Title: CONSULTATION REPORT: CNPA RESPONSE

TO ANGUS COUNCIL NOTICE OF INTENTION

DEVELOPMENTPROPOSED: CONSTRUCTION OF RA NGER CENTRE,

AT VISITOR CAR PARK, GLEN DOLL, ANGUS(FULLPLANNINGPERMISSION)

Fig.1 -LocationPlan

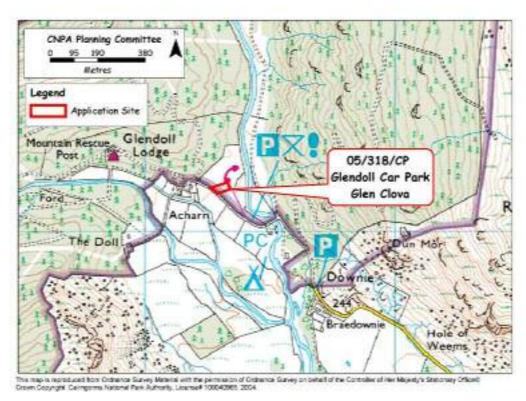
- 36. The site location is at the end of the single -trackroad, which leads up from the Clova Hotel to Glen Doll and is within the Deeside and Lochnagar National Scenic Area. The site is at the northern end of a substantial visitor car park within a dry stone wall enclosure, which hosts several small trees that would be removed to accommodate the proposal. The site is bordered on two boundaries by fields used for grazing with Jocks Road right of way that leads to Braemar passing along the western bou ndary of the site. The River South Esk passes approximately 40 metres to the east. The site is generally flat and partly screened by a range of trees. An existing small visitor information centre on the car park would be removed, as would toilet blocks t o the south east of the site. It is understood that there was formerly a Scottish Natural Heritage (site owners) building on the site, which was removed. The general environment of the site consists of thecarparkwithgrassedareasandpicnicbenches;th ereisarangeof maturetreesaroundthesite.
